STATE OF MAINE
DEPARTMENT OF TRANSPORTATION
☐ Approved
☐ Returned for Corrections
AUG 2[illegible] 1997
☒ Approved as noted
☐ Rejected

PROJ. NO. : BH-043-1(34)
ITEM NO. : 520.22

PROJECT: JOSHUA CHAMBERLAIN BRIDGE OVER THE PENOBSCOT RIVER, BANGOR-BREWER, ME

EXPANSION JOINT DETAIL @ PIER 1

SECT. C-C

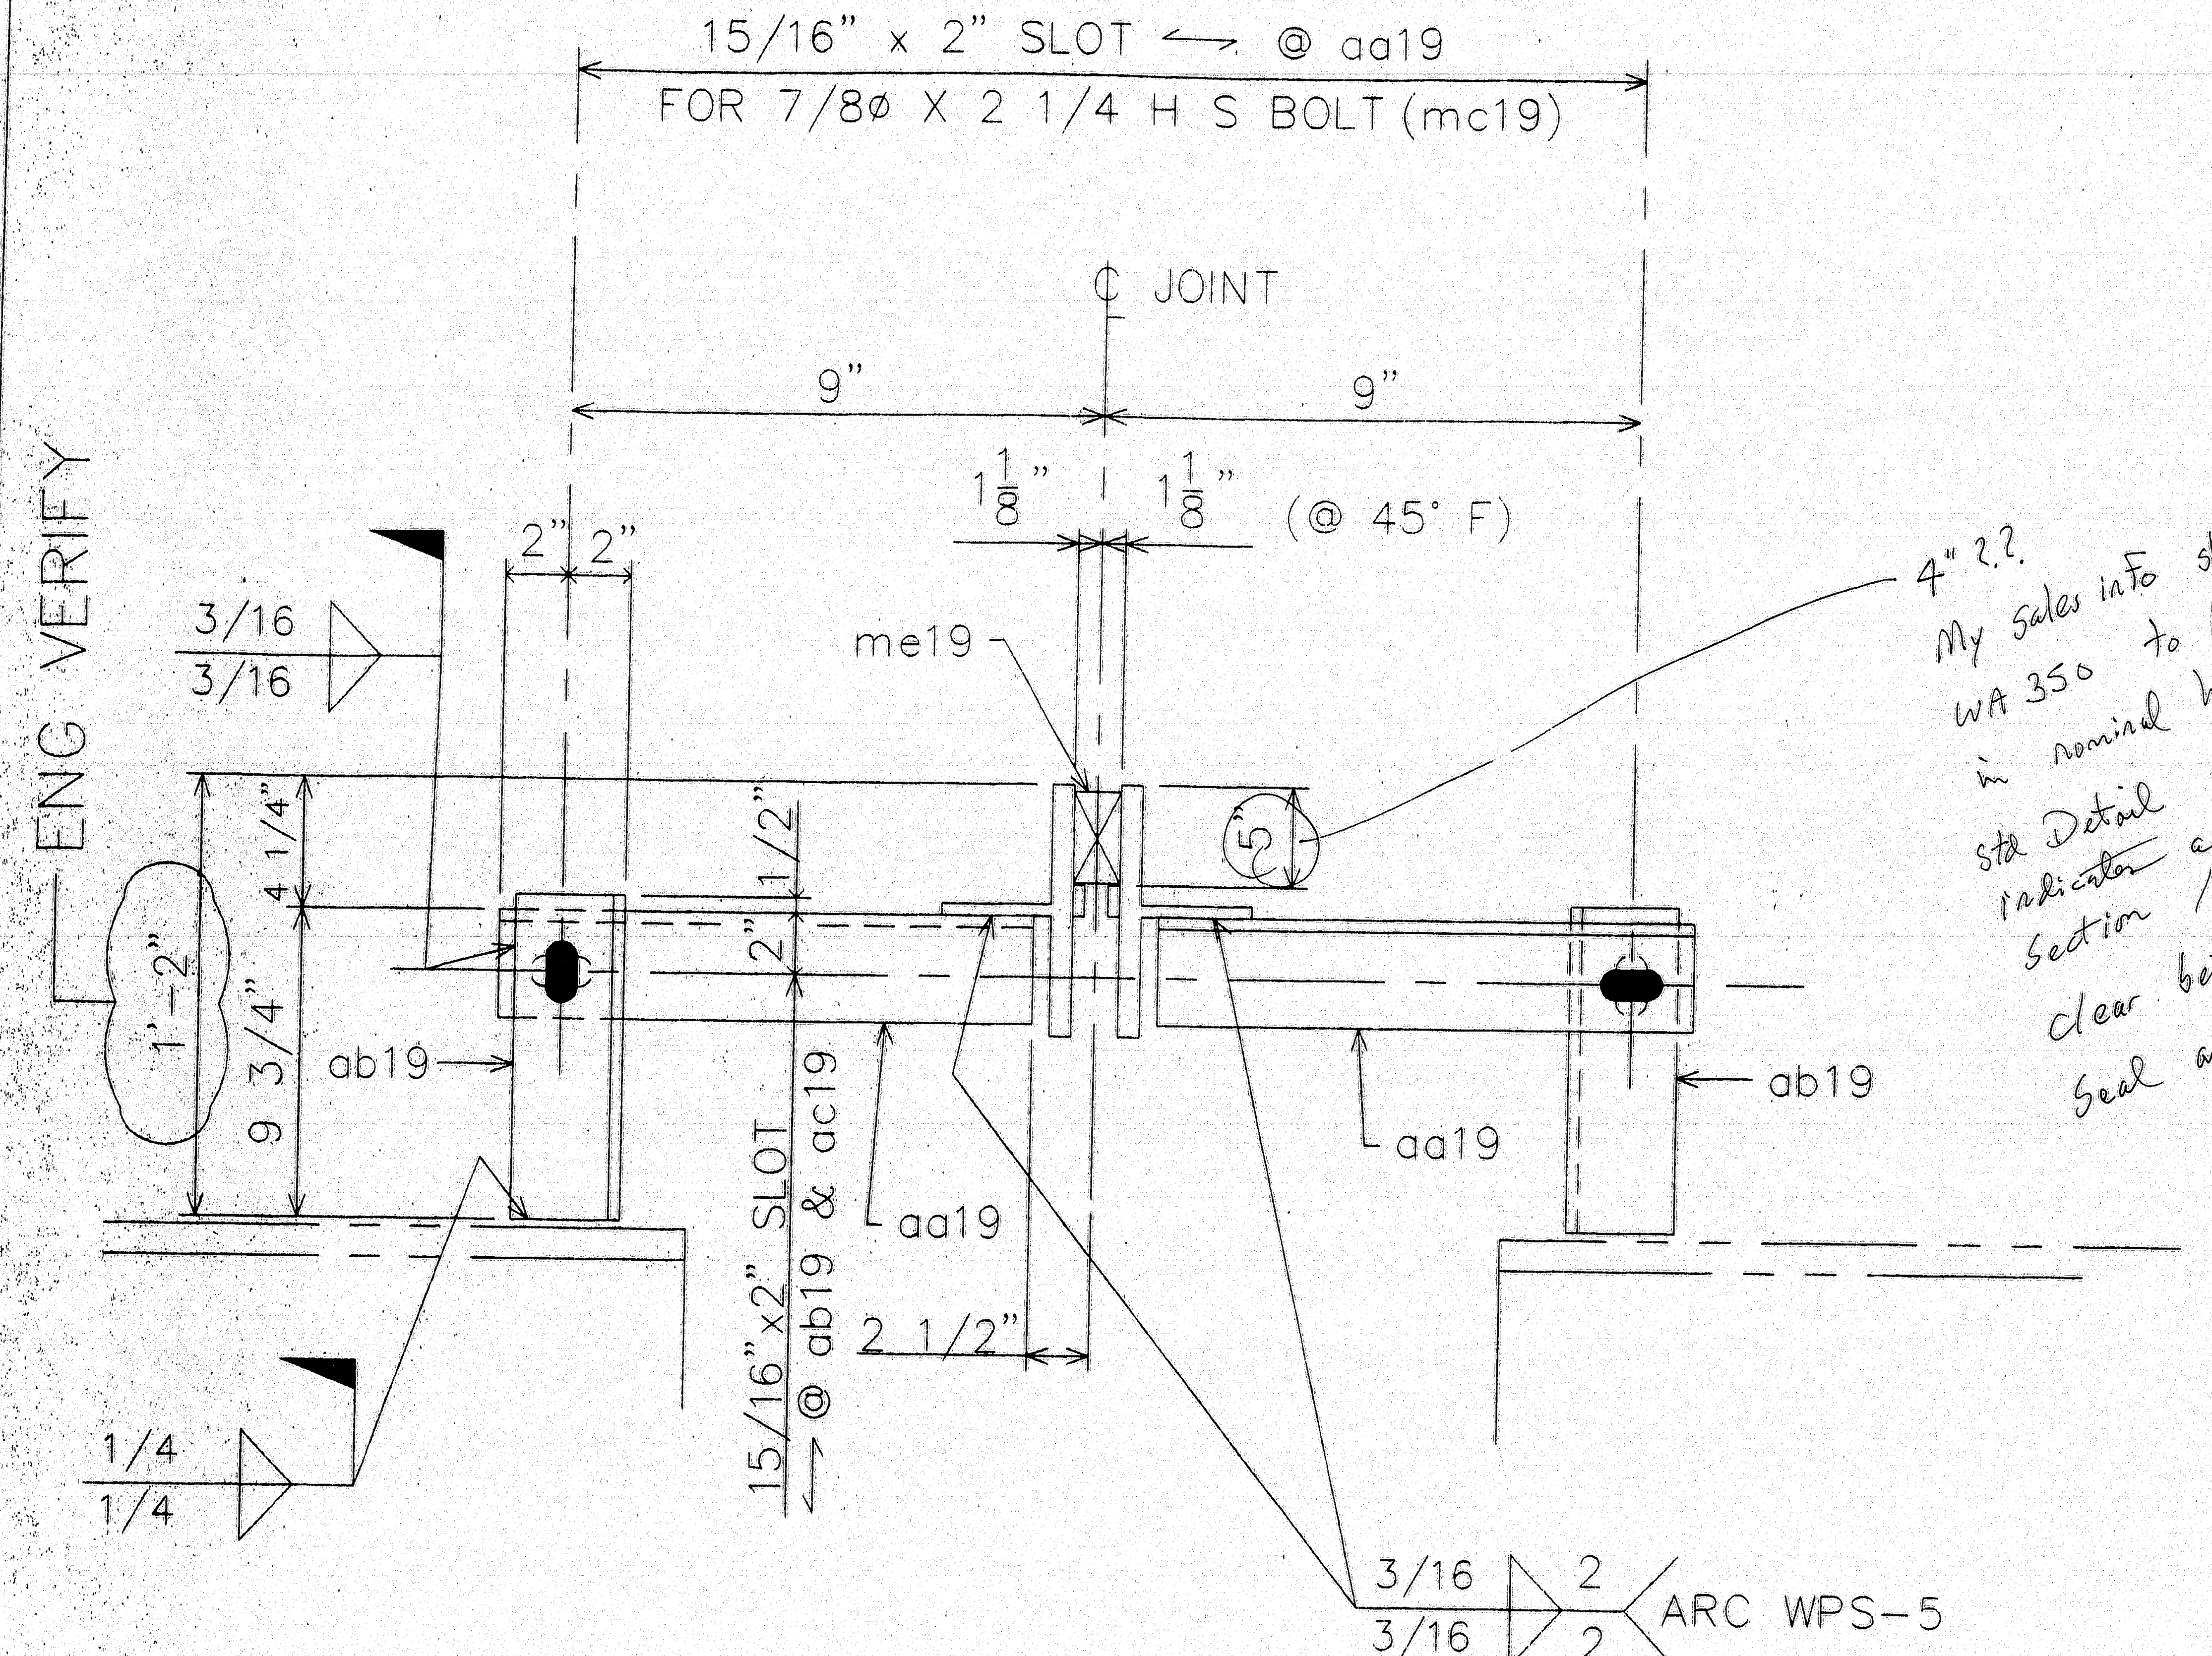
4" ?? My sales info shows a WA 350 to be 3½" in nominal height. std Detail BD-301-93 ~~indicates~~ a typical Section leaves a ½" clear between top of seal and top of ~~T~~ flange.

3½" + ½" = 4" ??

ONE-EXPANSION JOINT-A10
(PLAN)

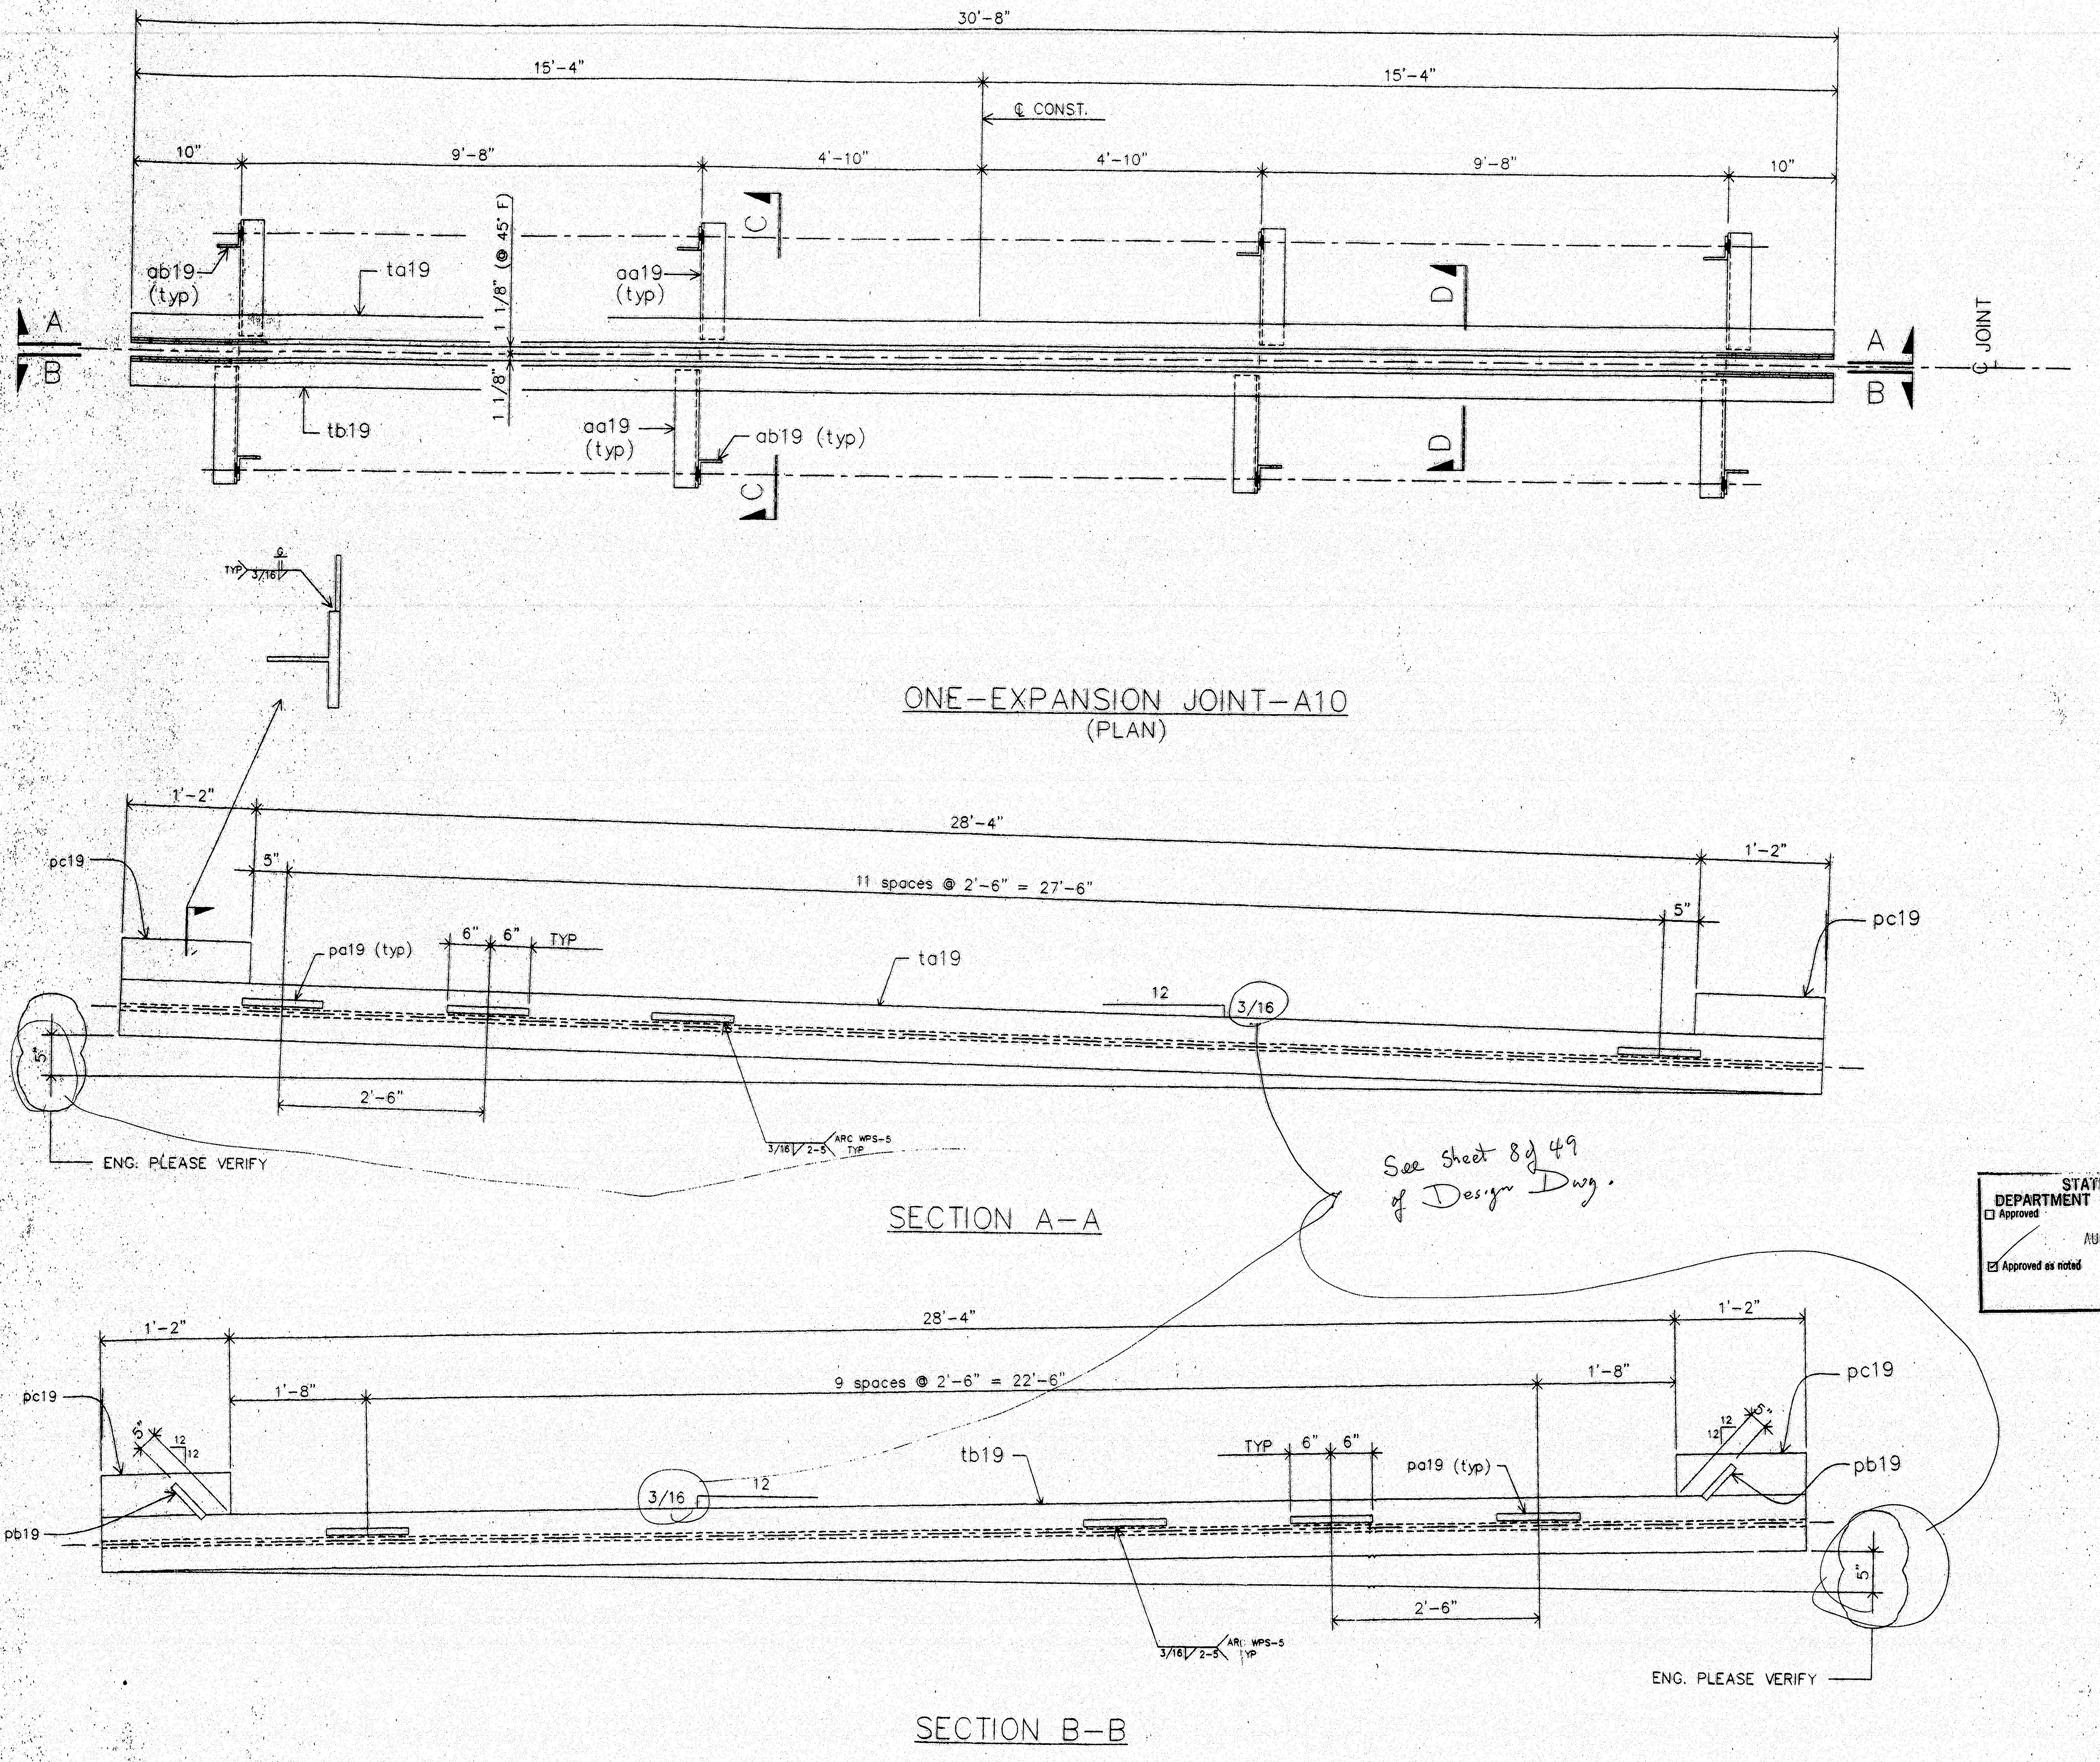
See sheet 8 of 49 of Design Dwg.

TEMPERATURE ADJUSTMENT CHART

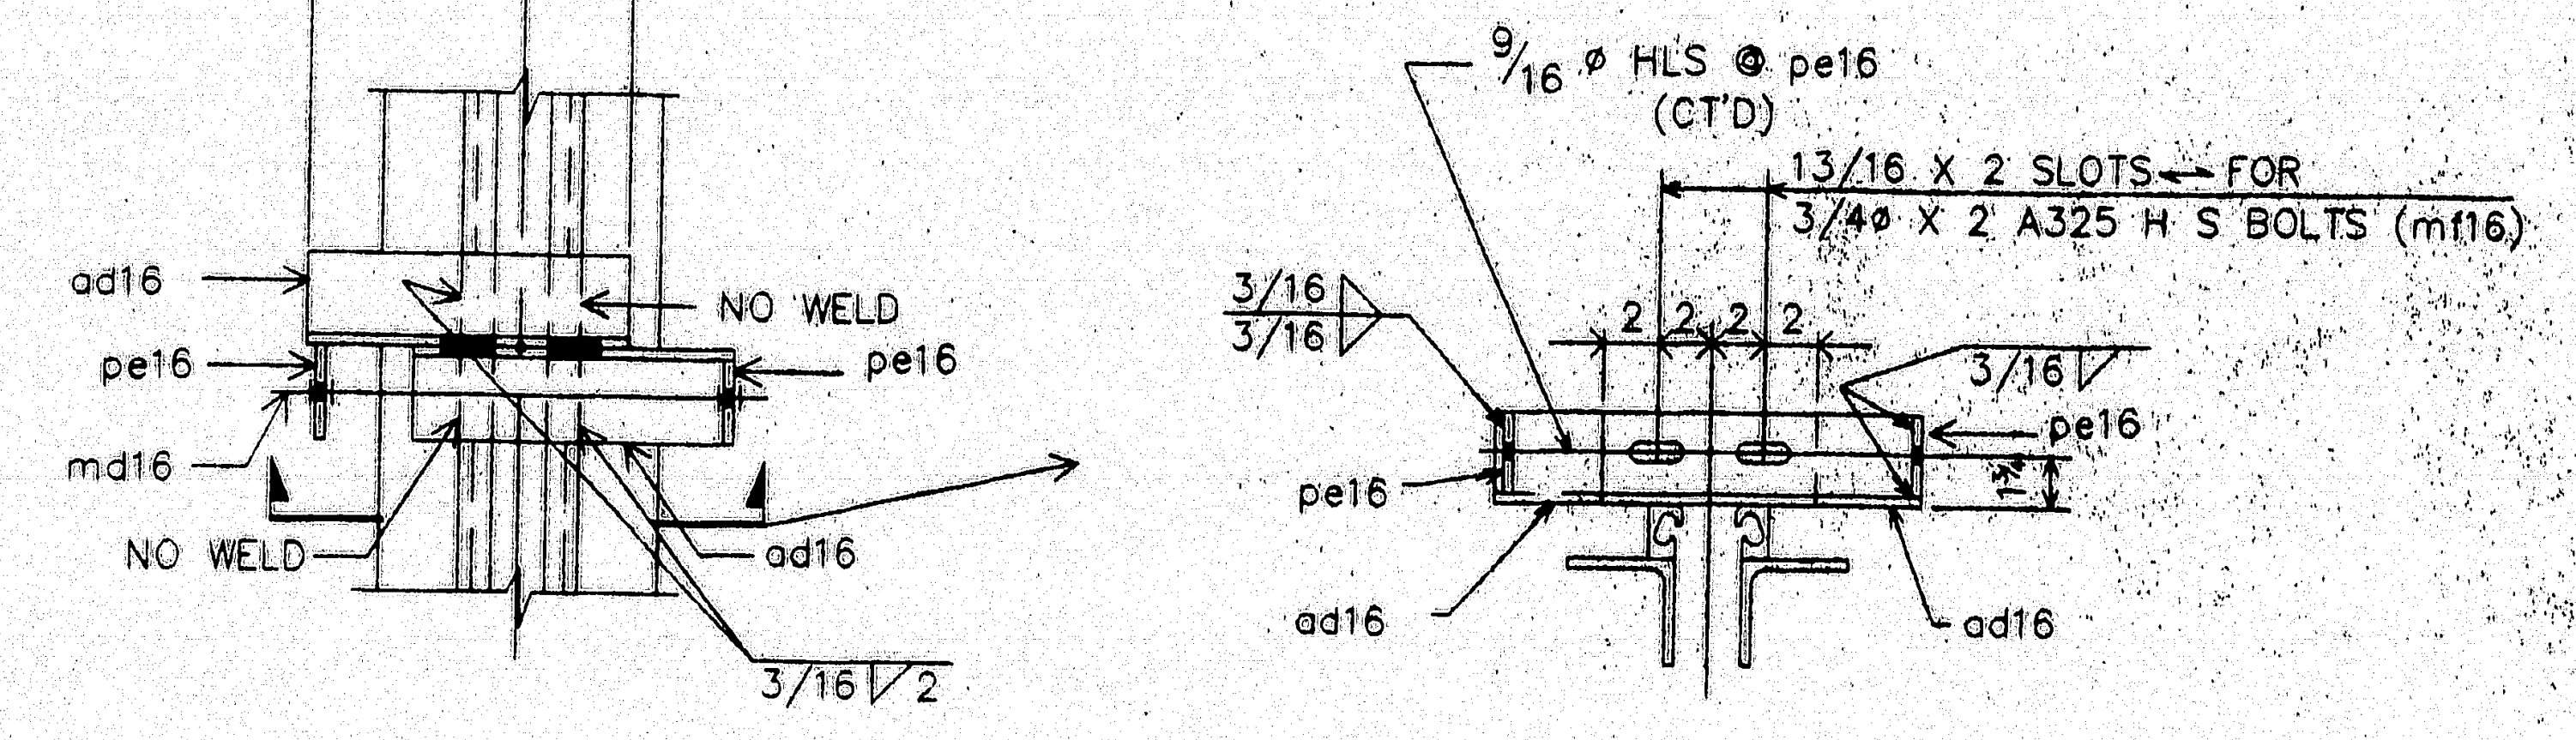
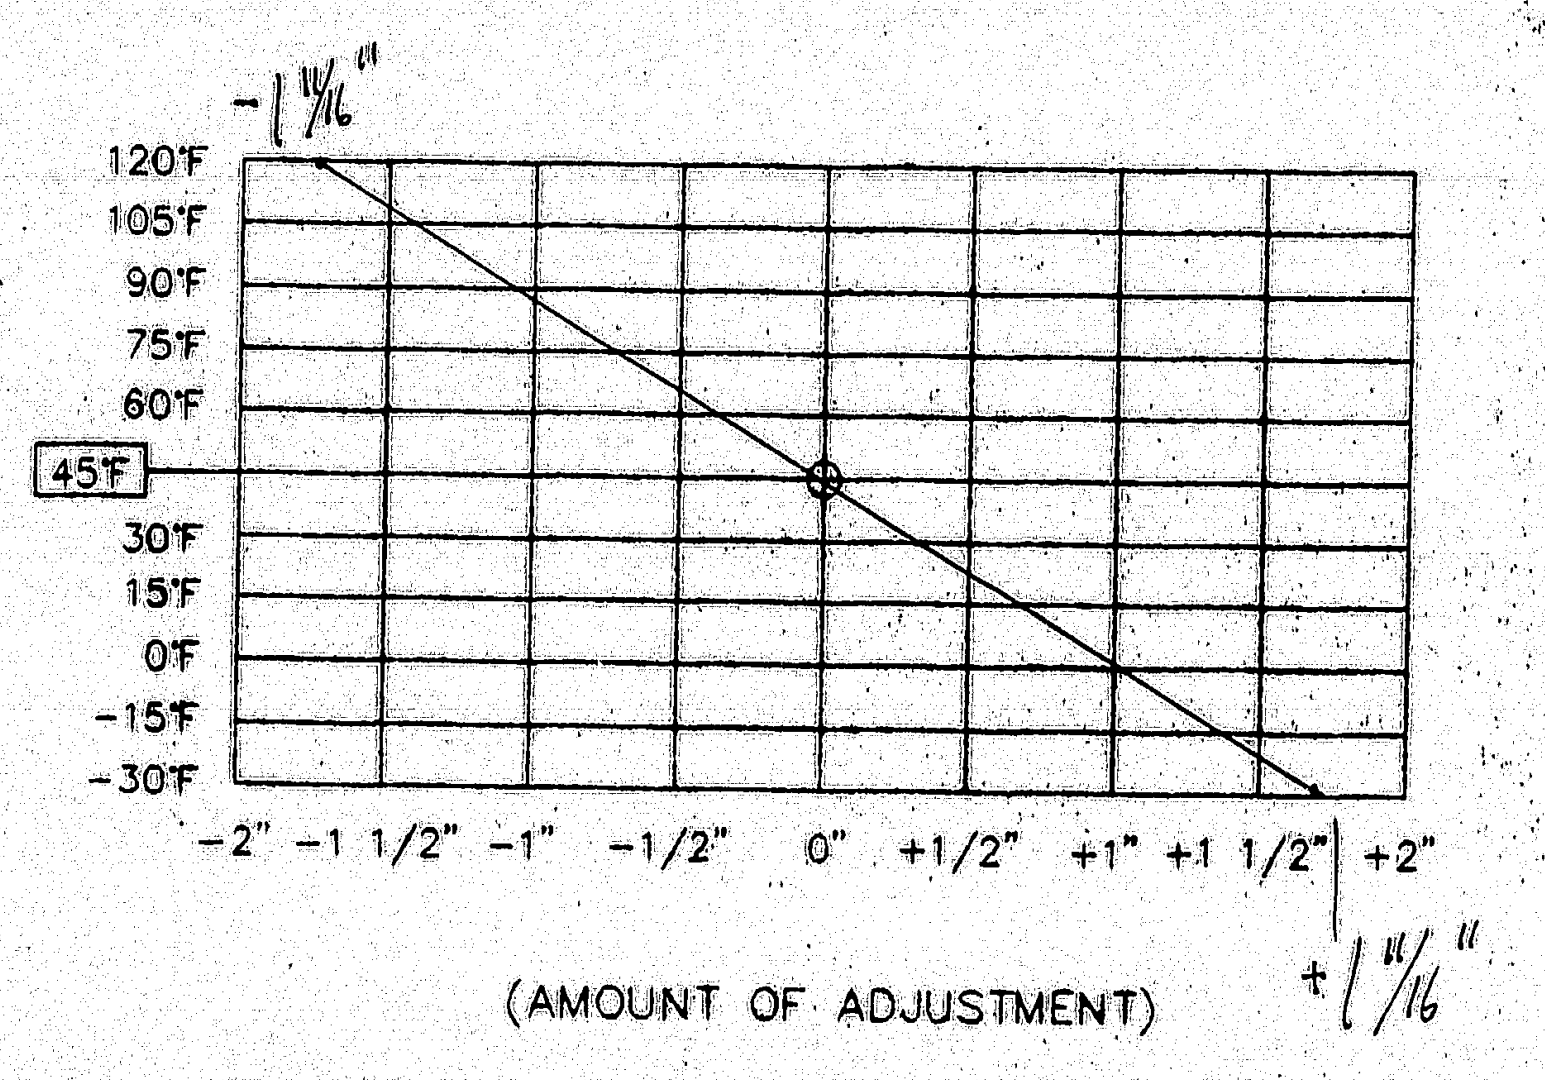
ENG. PLEASE PROVIDE THE AMOUNT OF MOVEMENT FOR THIS JOINT. NOT SHOWN ON DESIGN DWGS.

Sheet 23 of 49 Design Dwg:
Note 2 says use BD 302-93.
BD 302-93, Note 4 depicts formula:

$$\text{Correction per } 10°F = \frac{0.0125" \times L(\text{exp})}{15}$$

Sheet 8 of 49 Design Dwg:
Distance is appx. Pier 14 to Brewer Abut.

Sta 38+08
Sta 35+38
270 feet

$$\frac{\text{Correction}}{10°F} = \frac{0.0125 \times (270)}{15} = 0.225$$

45° to -30° is 75°... so, 7.5 × 0.225 = 1.6875 each side of 45°F.

$\therefore = 1\frac{11}{16}"$

MATL: A36 UN HOLES: AS NOTED
WELD: PER PROCEDURES NOTED
PREP: SP6
FINISH: 3 COATS ZINC RICH PRIMER
3 MDFT PER COAT

2 coats ok.
